STATE OF HAWAII
DEPARTMENT OF TRANSPORTATION
HIGHWAYS DIVISION

DEMOLITION & GRADING PLAN

OAHU DISTRICT WAREHOUSE BUILDING

Project No. HWY-0-05-98

SEWERLINE

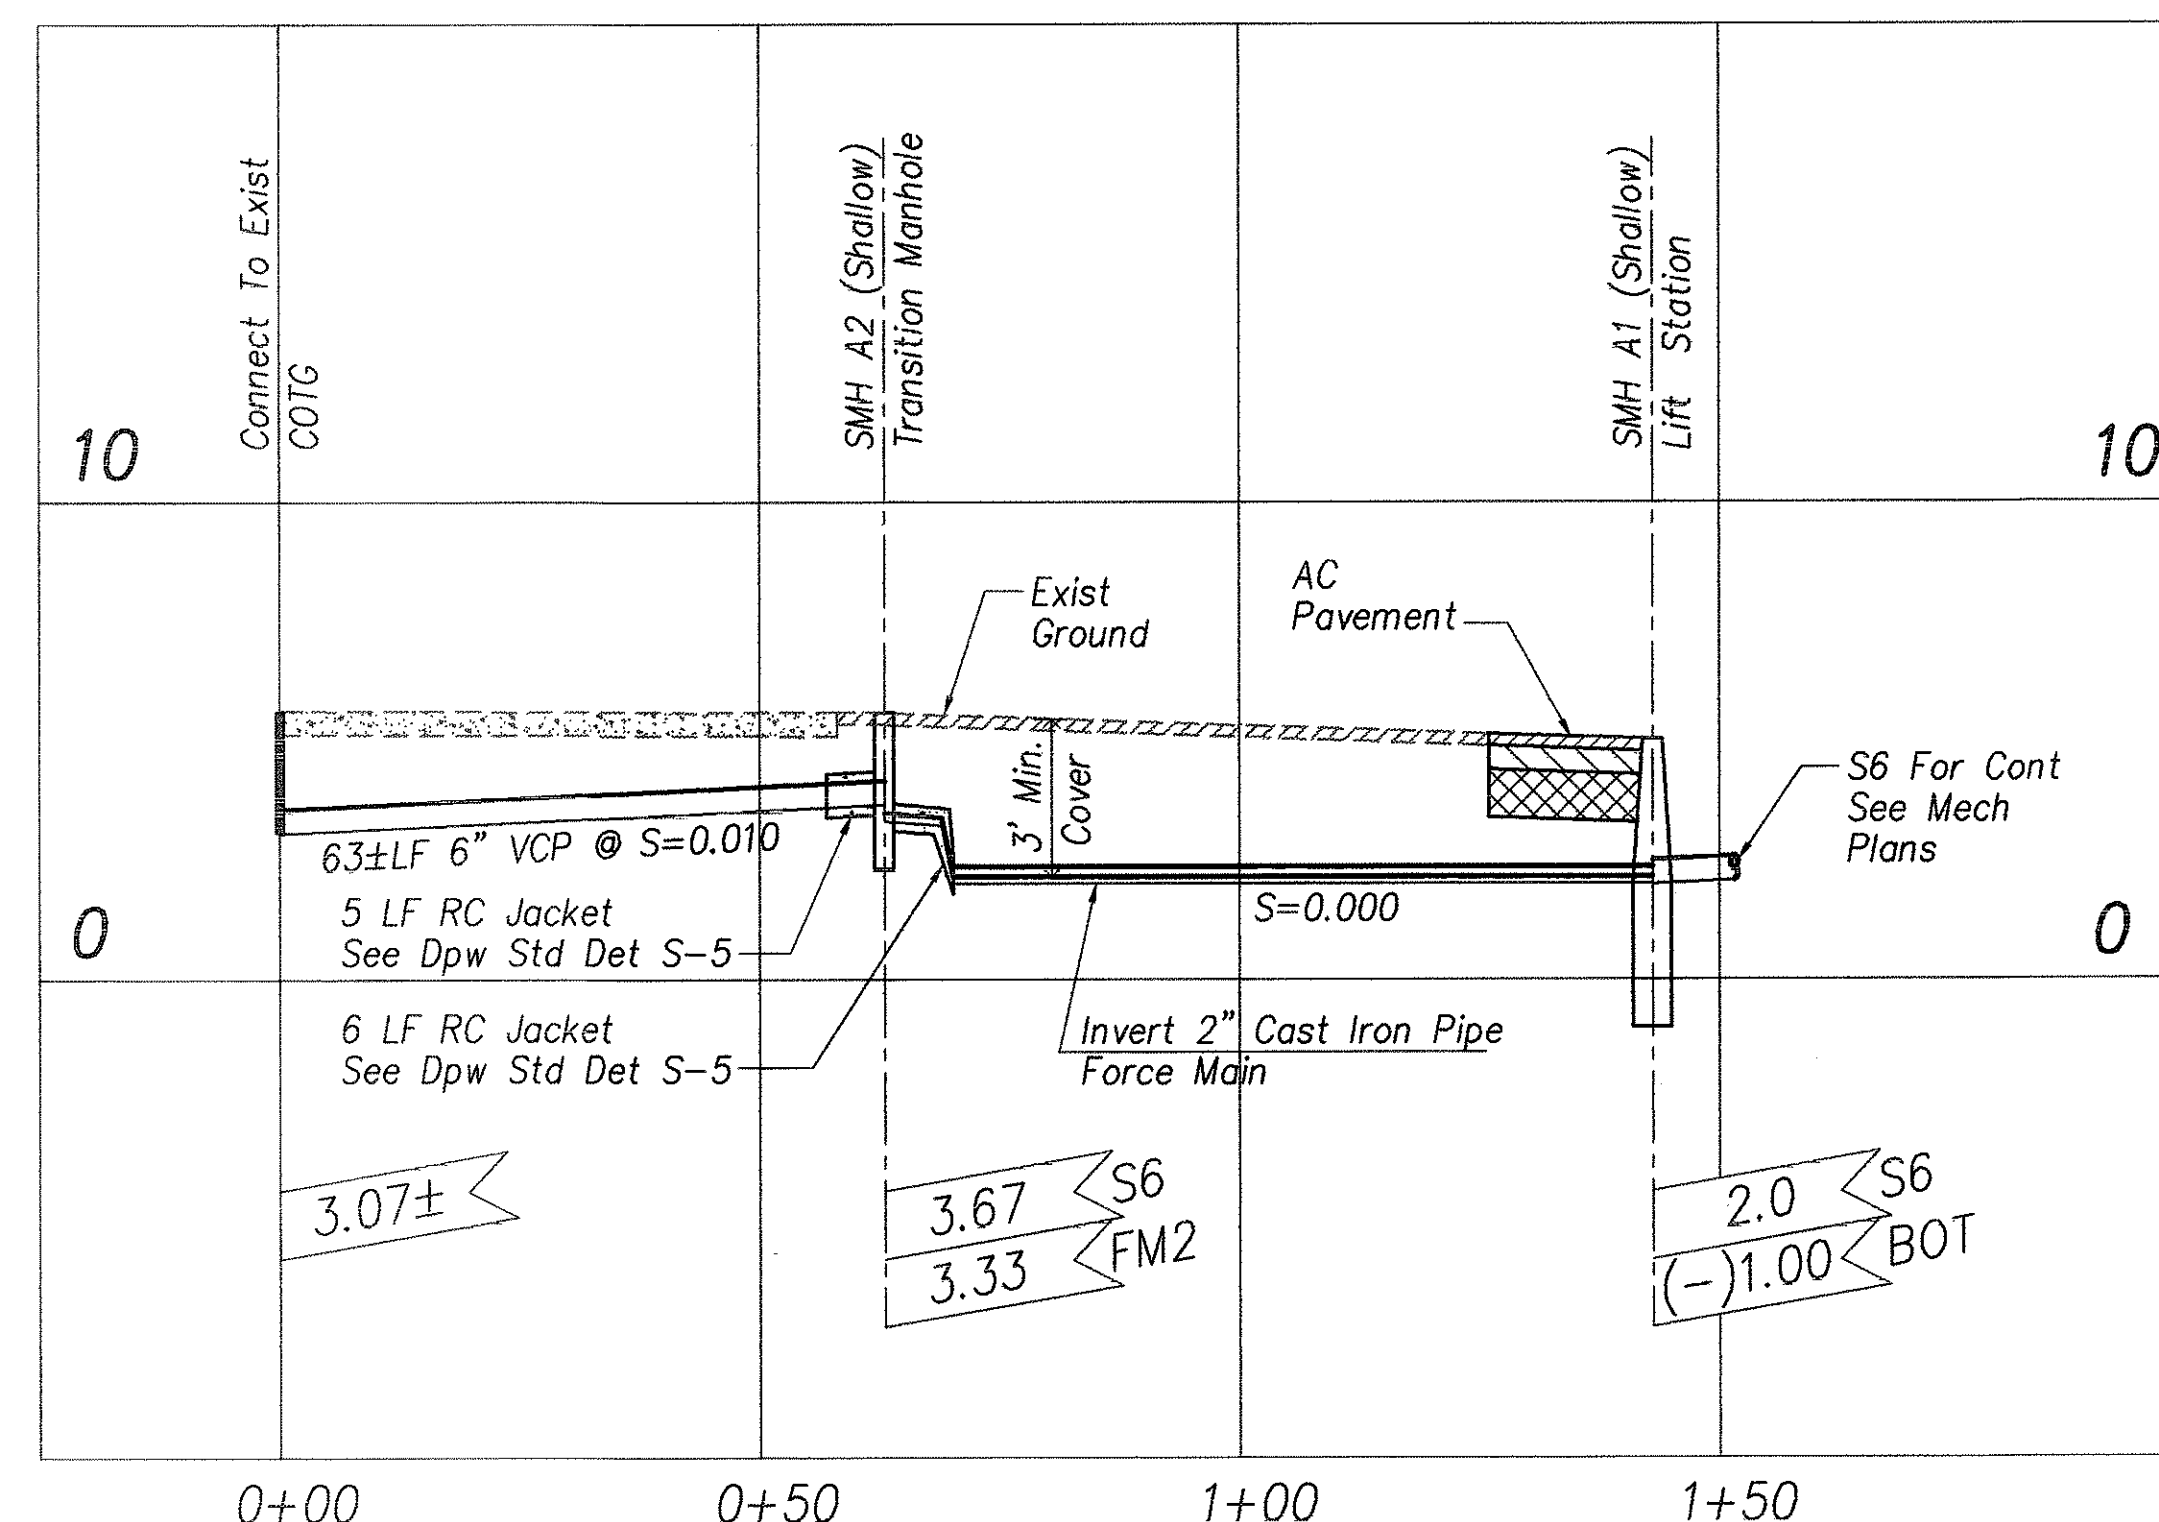
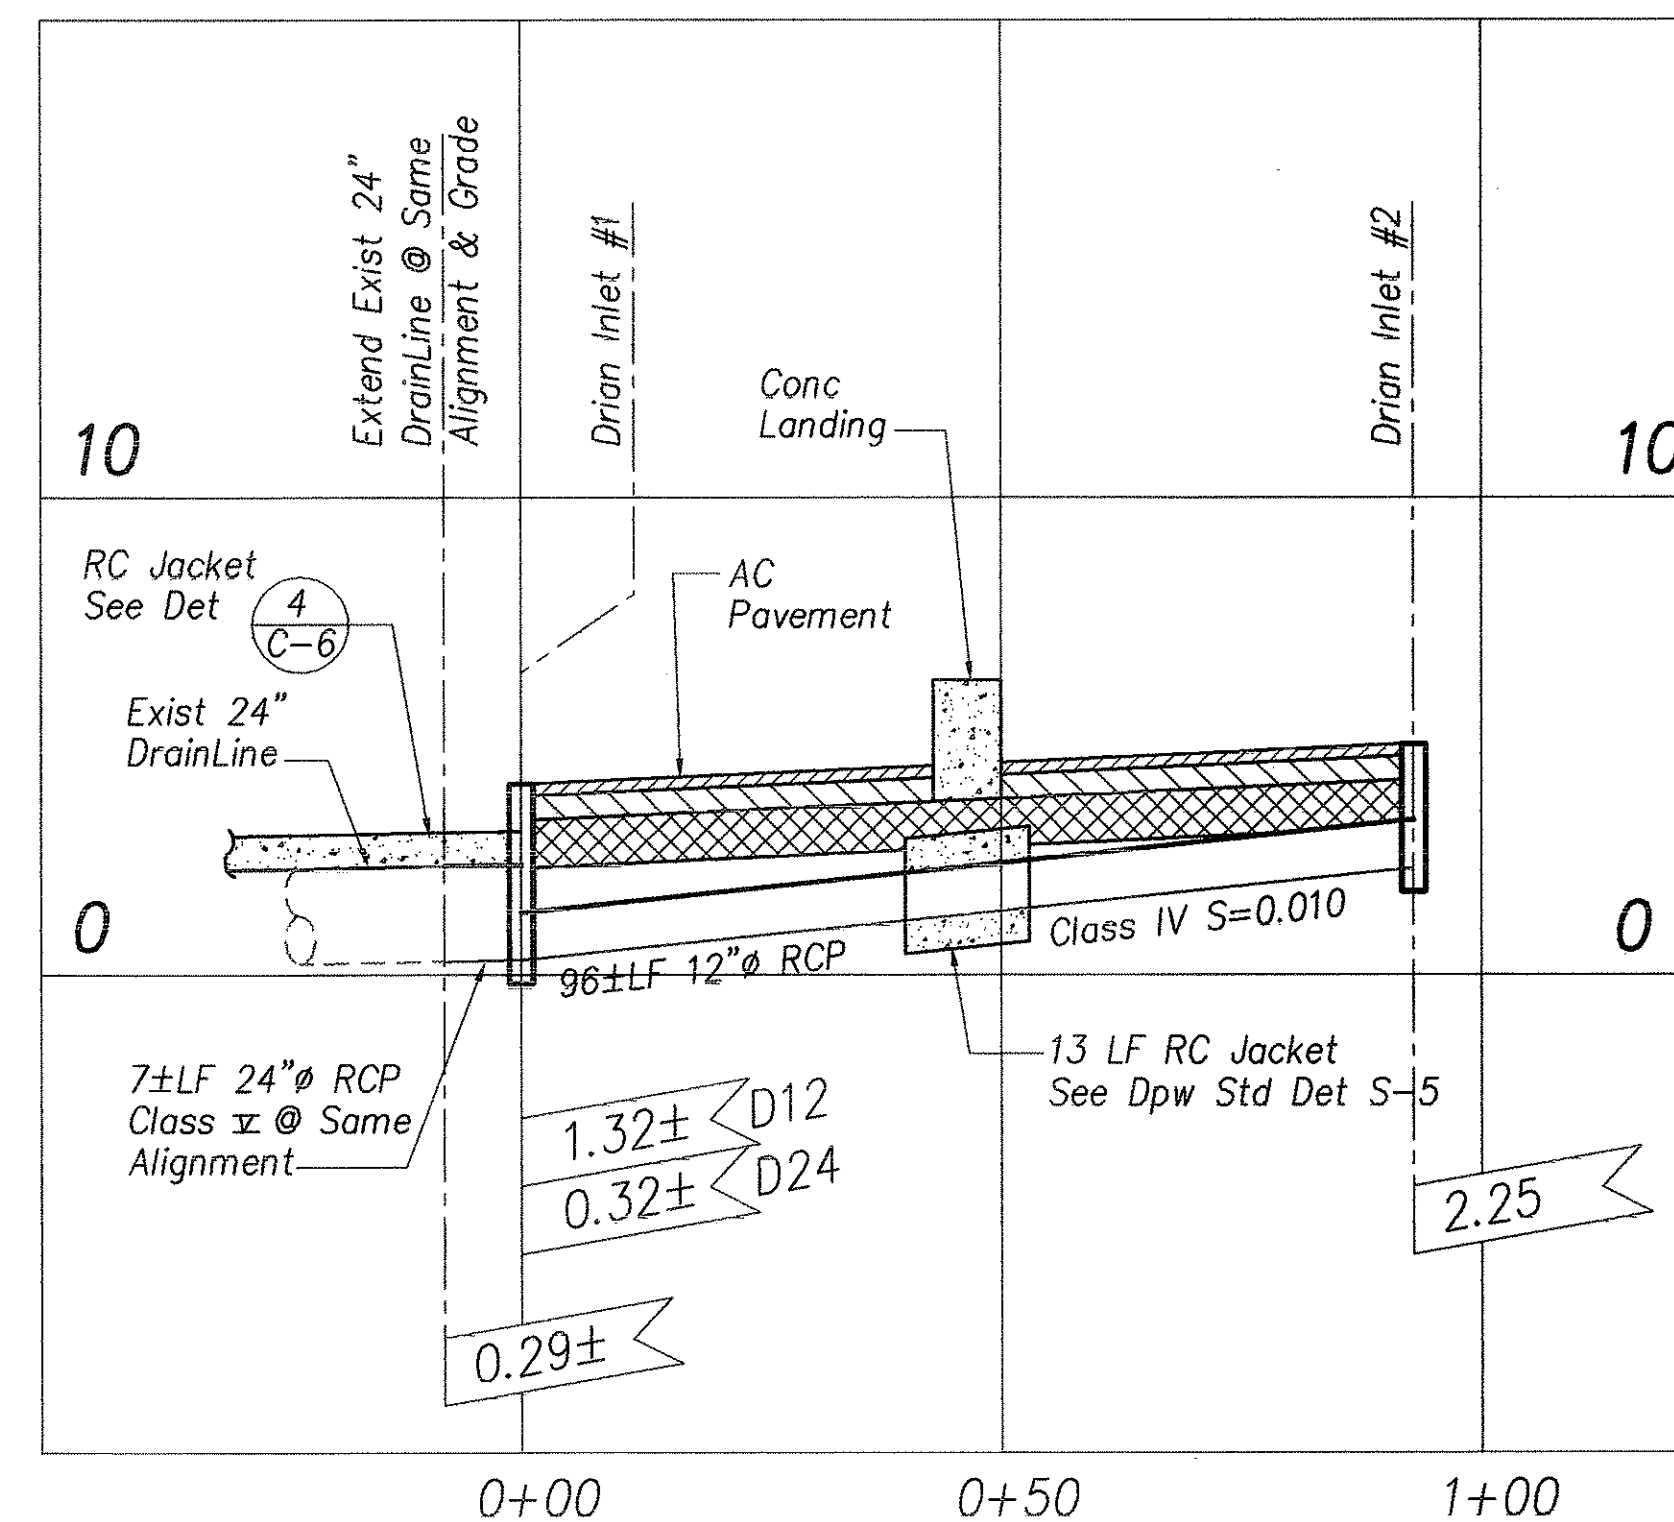
7/17/2000	PCD 1	Add BWS Notes
June 2000		Rev. Sewer & Drain Profile
Date		Revision
STATE OF HAWAII DEPARTMENT OF TRANSPORTATION HIGHWAYS DIVISION		
PROFILES		
OAHU DISTRICT WAREHOUSE BUILDING		
Project No. HWY-0-05-98		
Scale: AS SHOWN		Date: APRIL 2000
SHEET No. C3 OF 116 SHEETS

3 **CONC PAVEMENT RESTORATION**
C-5 Scale: 1"=1'-0"

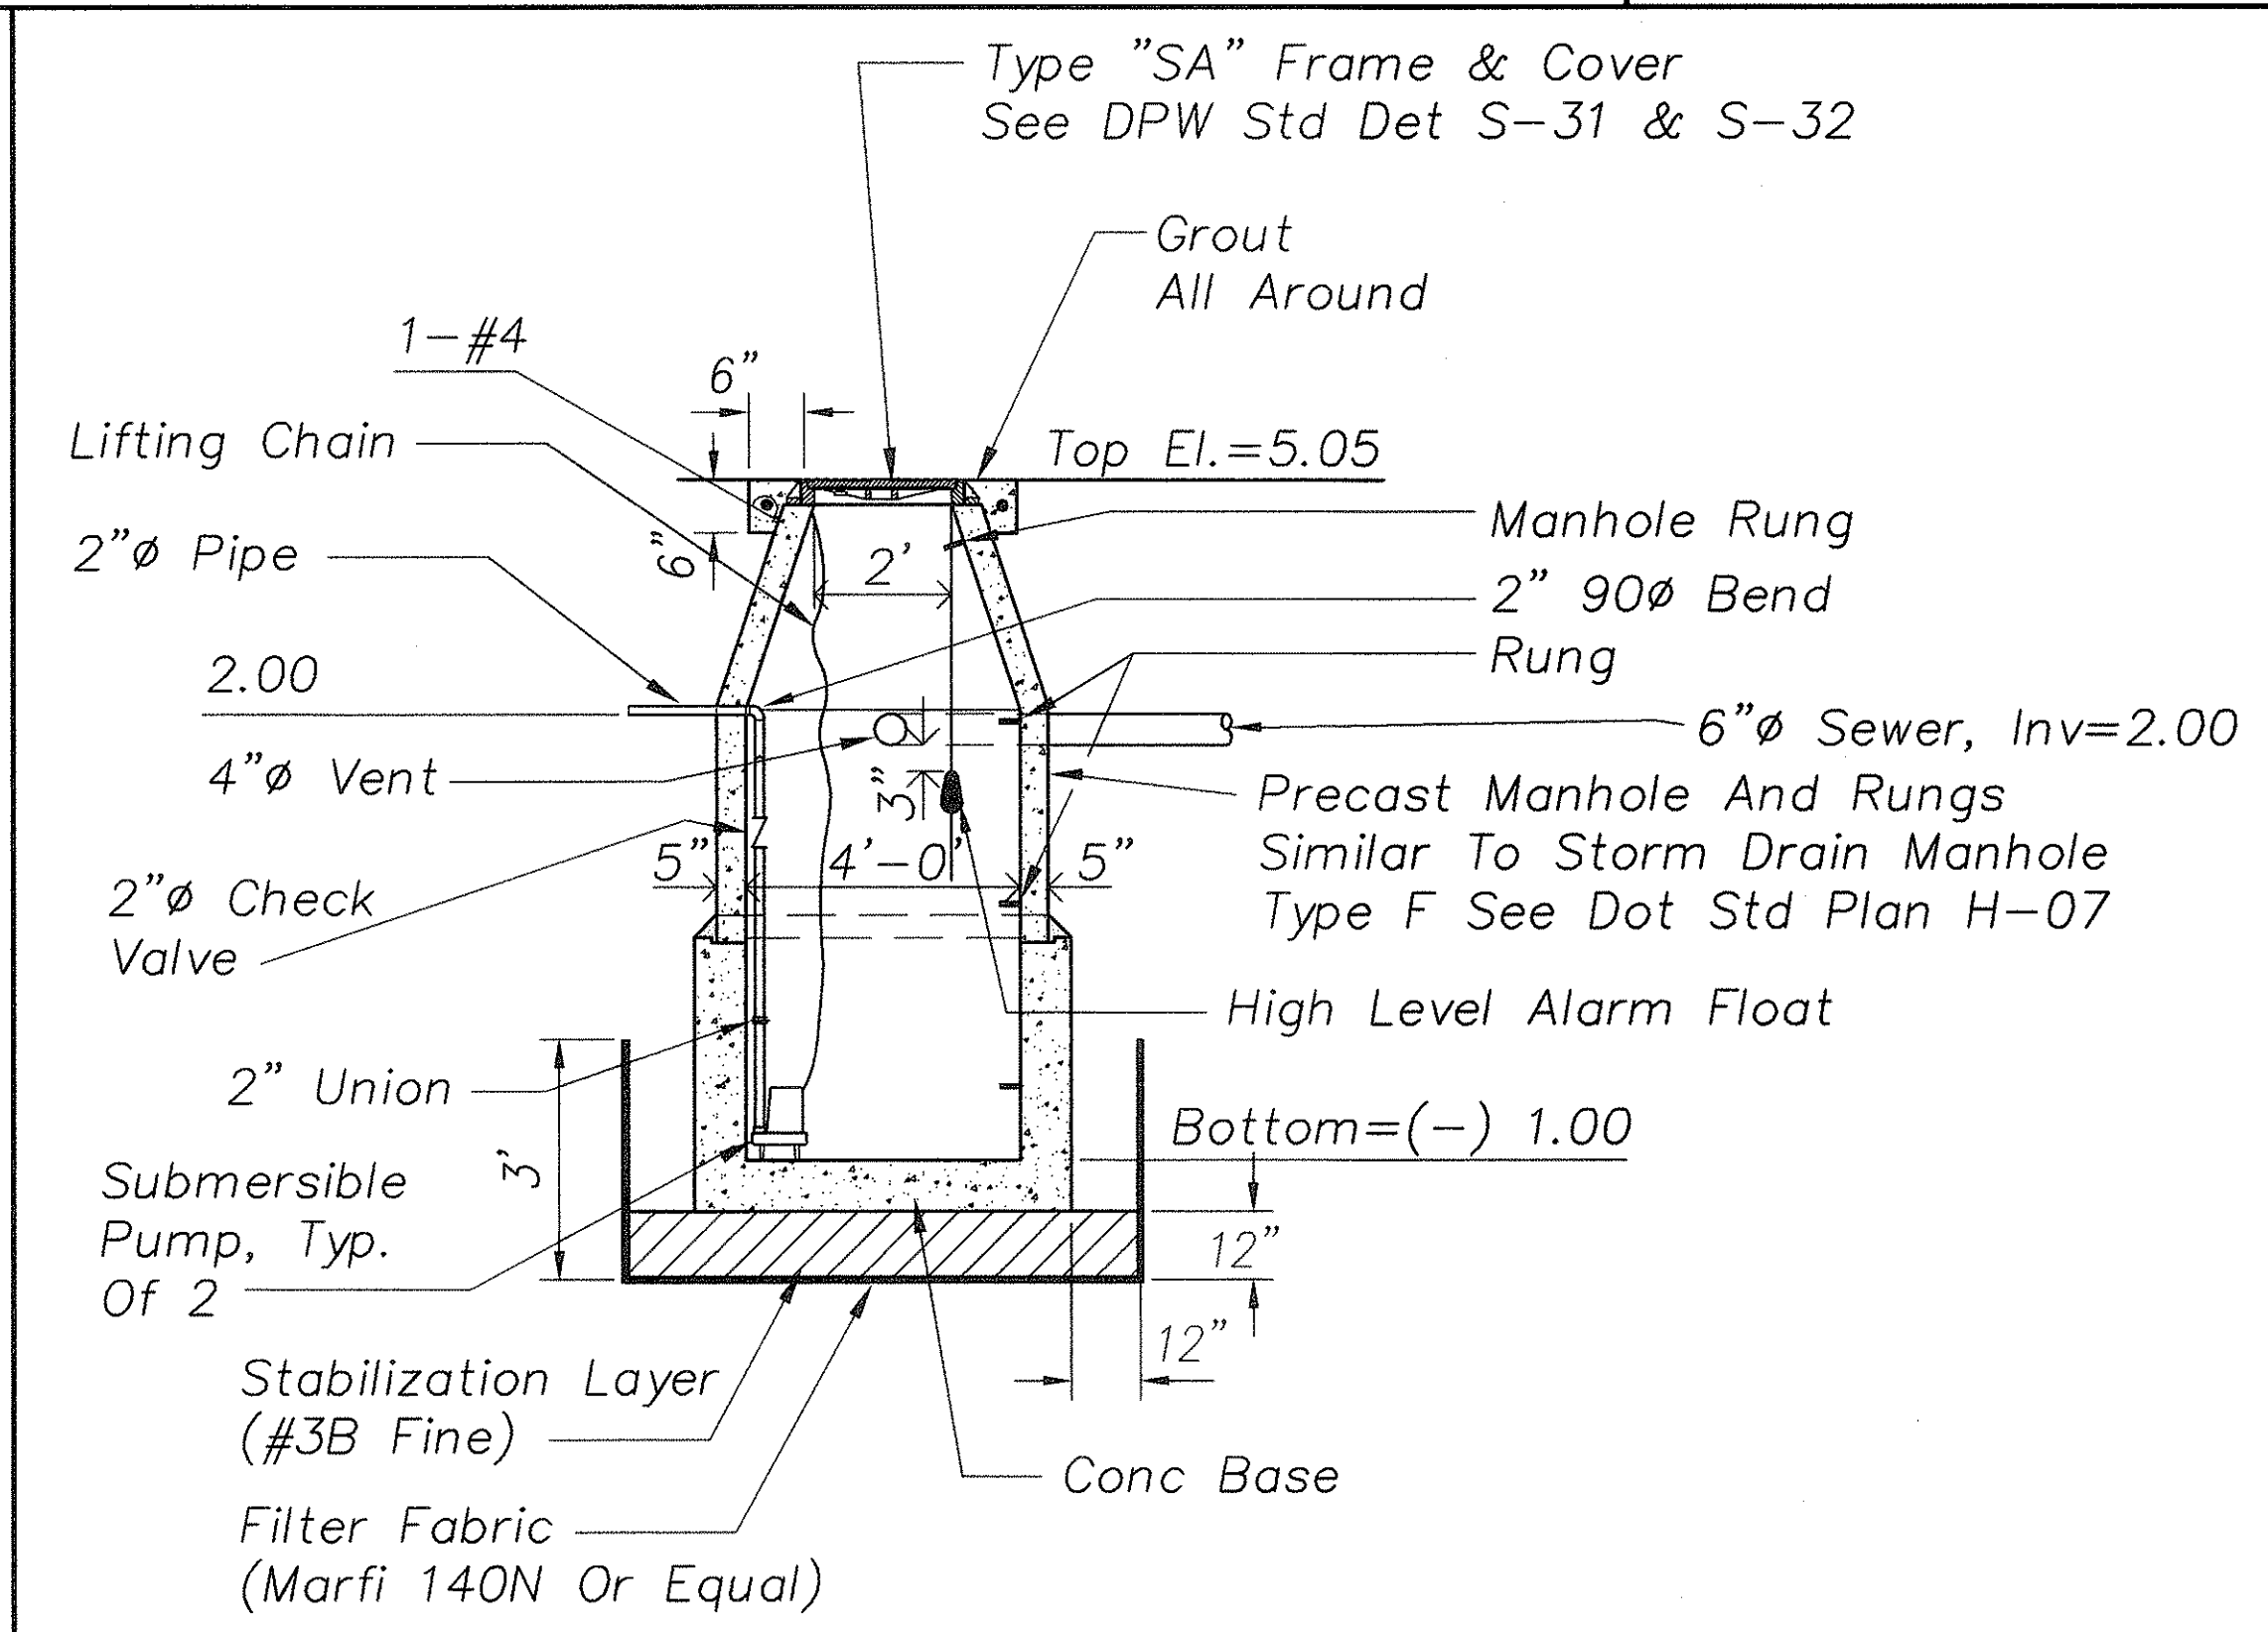
June 2000	Rev. Conc Pav't Restoration & Pump Lift Station
Date	Revision
STATE OF HAWAII DEPARTMENT OF TRANSPORTATION HIGHWAYS DIVISION	
DETAILS	
OAHU DISTRICT WAREHOUSE BUILDING	
Project No. HWY-0-05-98	
Scale: AS SHOWN	Date: APRIL 2000
SHEET No. C5 OF 116 SHEETS

2 CONCRETE THRU GUTTER
SCALE: 1"=1'-0"

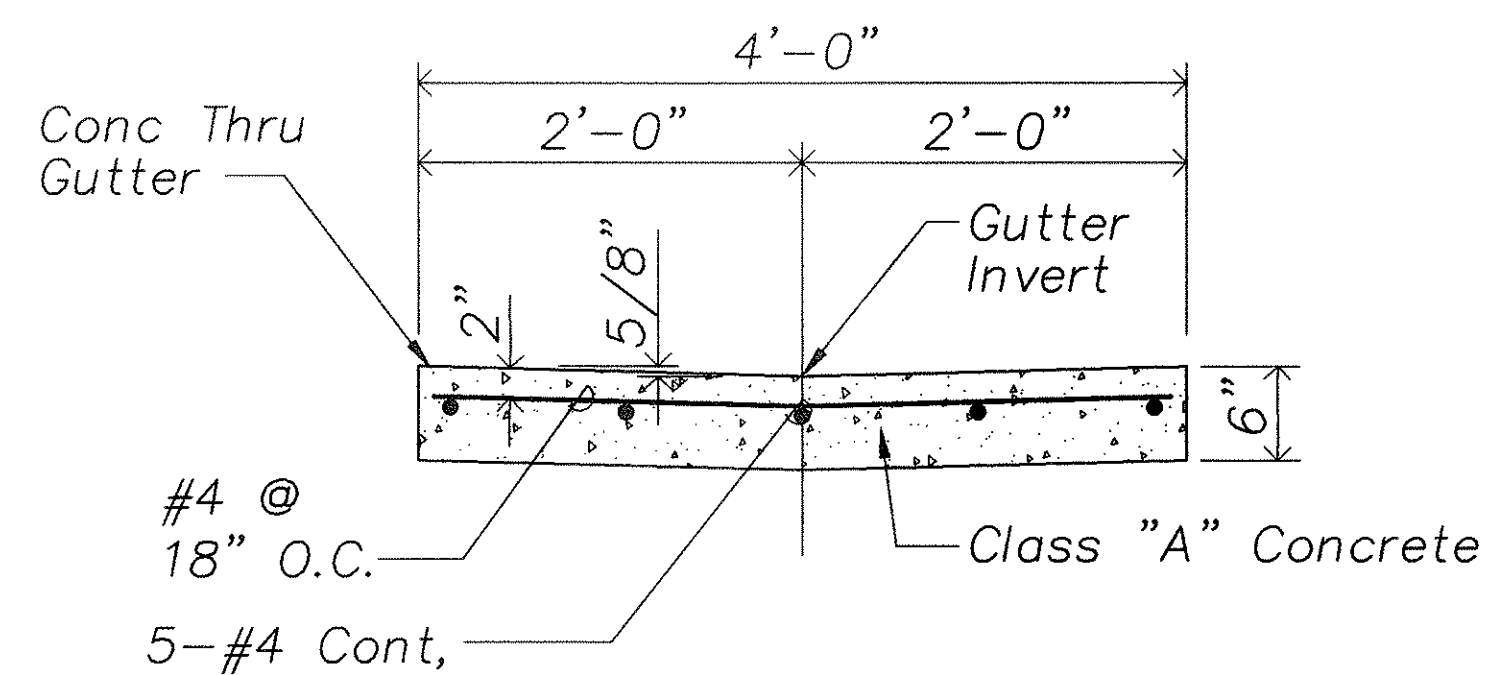
C-6	Rev. Conc Wall, Conc Thrust Gutter, Conc Jacket & Drain Inlet Details
June 2000	
Date	Revision
STATE OF HAWAII DEPARTMENT OF TRANSPORTATION HIGHWAYS DIVISION	
DETAILS	
OAHU DISTRICT WAREHOUSE BUILDING	
Project No. HWY-0-05-98	
Scale: AS SHOWN	Date: APRIL 2000
SHEET No. C6 OF 116 SHEETS
